AMERICAN BRASS INCORPORATED SUPERFUND SITE

Value Engineering Study
For
U.S. Environmental Protection Agency
Region 4 Atlanta, Georgia

Study Date: February 19 - 21, 2008
April 07, 2008

Appendix B – Picture of RA Construction Schedule

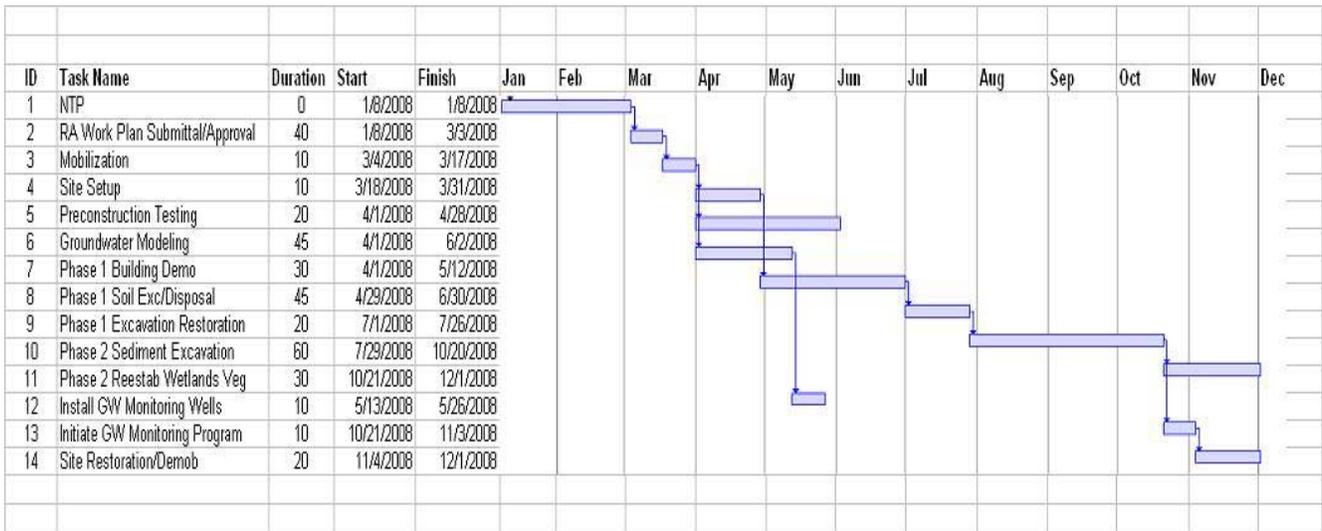
NOTE II: This savings is independent of savings identified by modification of the excavation effort per recommendation (12,14, & 21) and would still be applicable at a prorated level to the work remaining in the event there is a scope reduction associated with the Cedar Creek former ball mill waste pile area.

ROD Fig 5

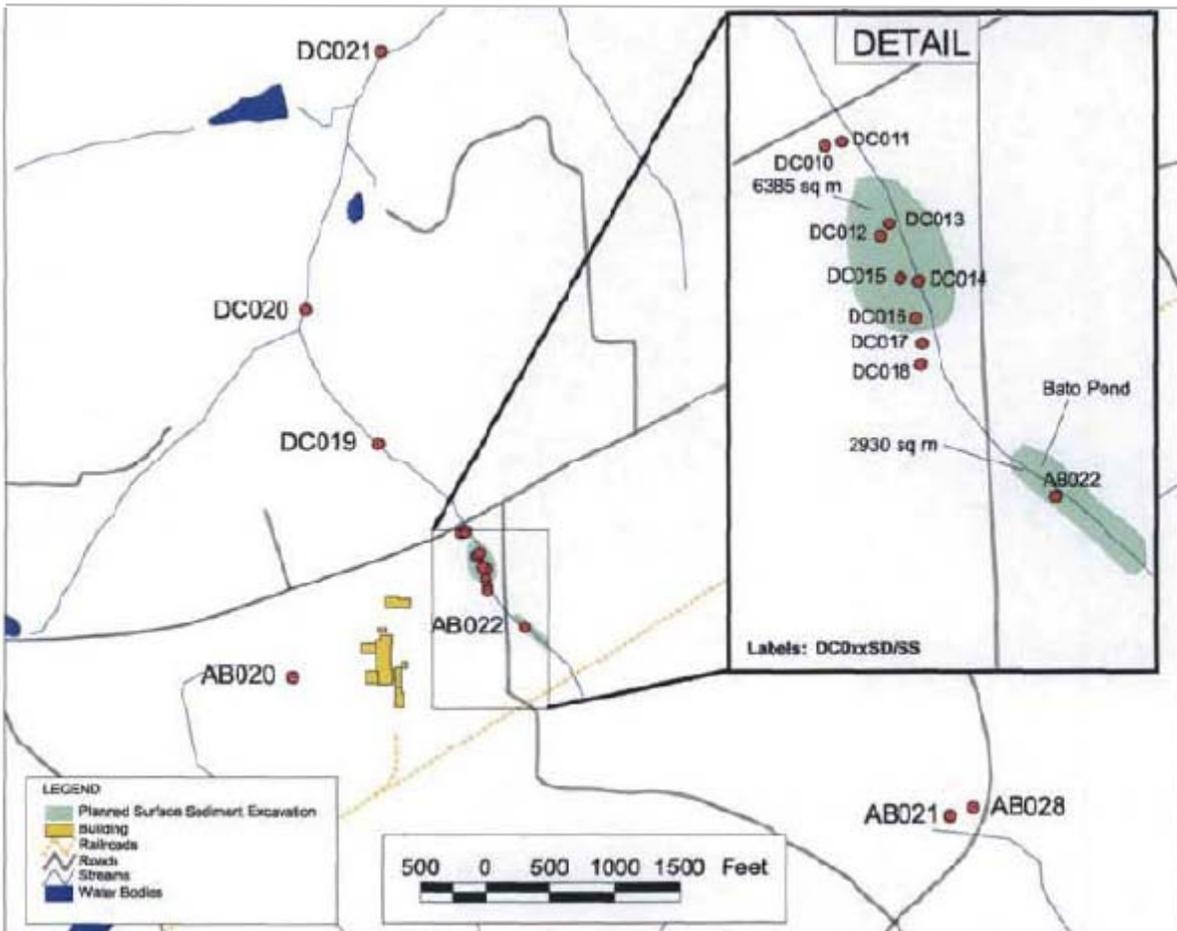
- Eliminates extensive added sampling (not quantified).
- Eliminates excavation of Bato Pond without impacting remedy effectiveness.
- Does not destroy the existing ecological habitat, while essentially meeting RGs over the entire Bato Pond area.
- Eliminates need to excavate, drain pond, reestablish the wetlands adjacent to two residences.
- Eliminates disposal and off site transportation of 1500 cy of material (Ref. ROD Fig 5).
- PCBs are a greater concern for the surface water (SW) pathway than inorganics which are readily bound by the organics present in wetland sediments making them immobile, PCBs are not an issue in Bato Pond.

Presently, this small wetland is thriving. And it is very close to two residences. Disturbing this pond would have significant detrimental impact to both the wetland and the adjacent residences and would provide minimal environmental cleanup.

Continued Next Page – Excavation Map

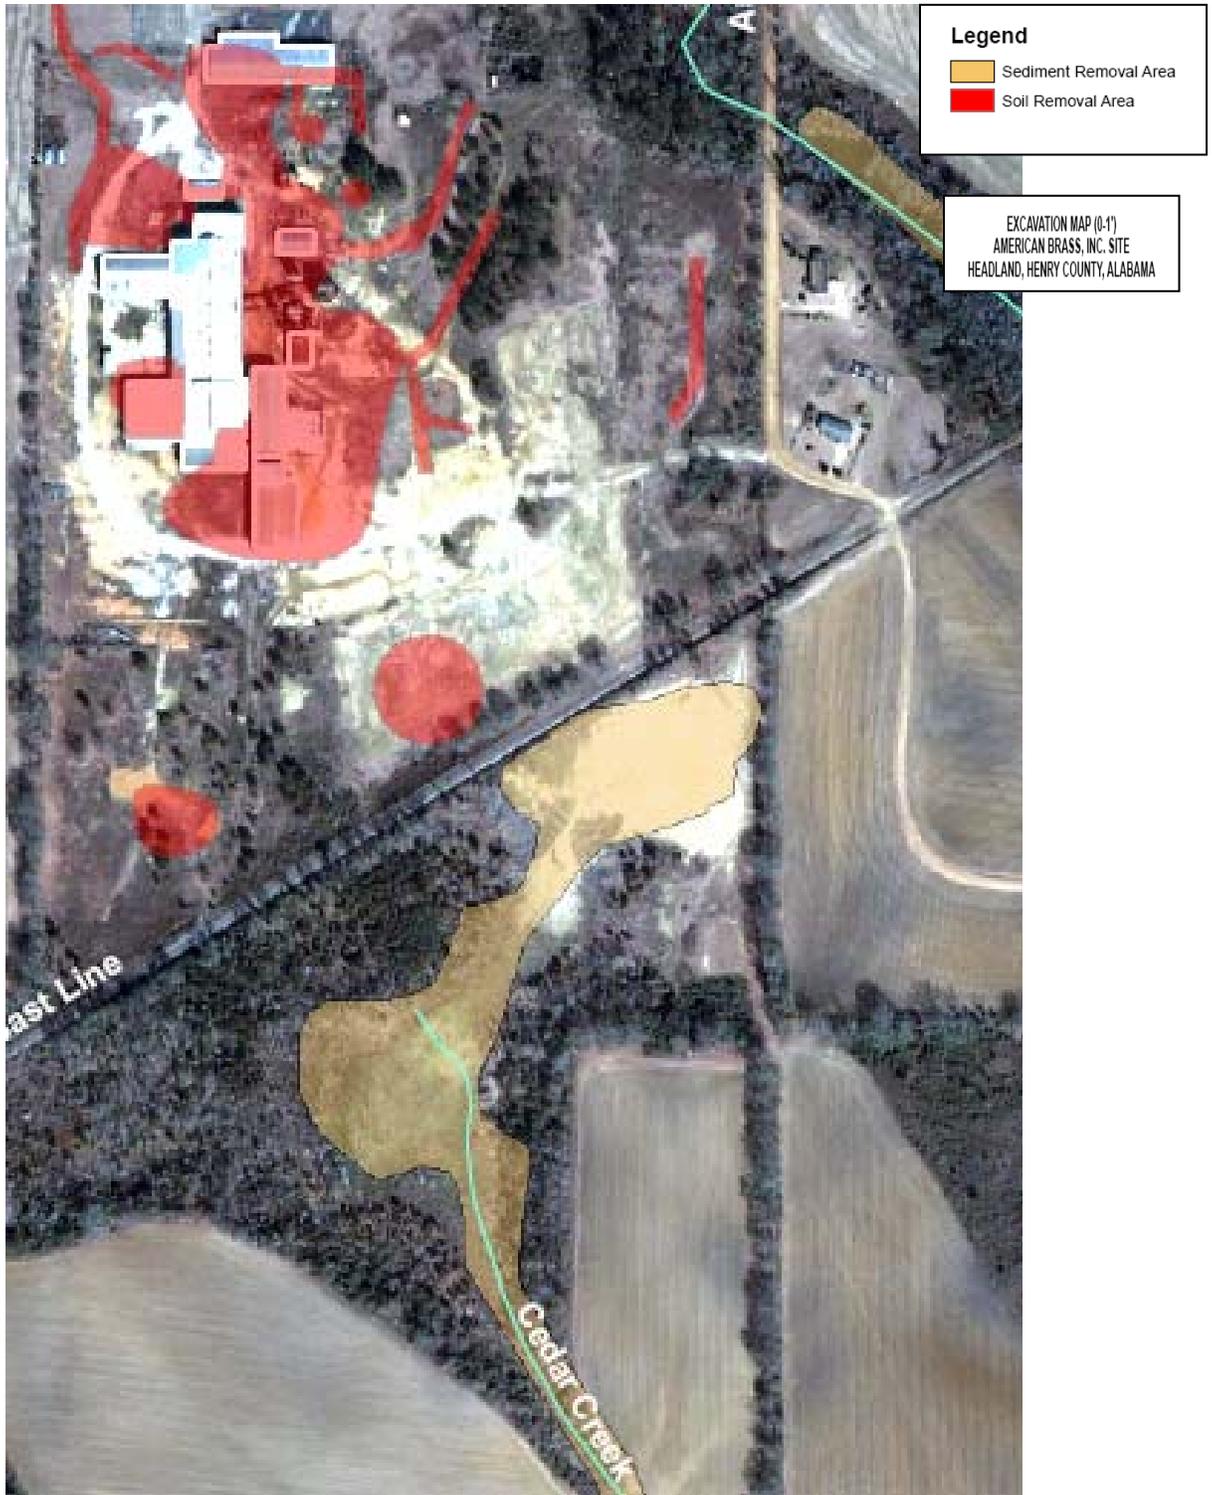
The current design for excavation at the Cedar Creek former ball mill storage pile calls for removal of material to a depth of 20 ft (or the water table) based on removal criteria generated from an ecological risk assessment. Much of the rest of site is an industrial area and per the new owners will remain so. Industrial criteria or groundwater protectiveness criteria would typically be applied to an industrial area though in this case application of residential PRG did not add significant additional volume so residential criteria were used for the site. One foot of soil will be removed in most of the excavations in the process area. Clean offsite material would be used to backfill all excavations.

It needs to be determined whether the material in the 1-5 ft interval would be deemed soil, which is most applicable since they are not in contact with wetlands or a water body, or sediment for which a lower cleanup criterion is applied. Since the soils are contaminated only with boron below 1 foot, modification of that designation could result in a reduction in the amount of soil excavated from 1-5 feet.
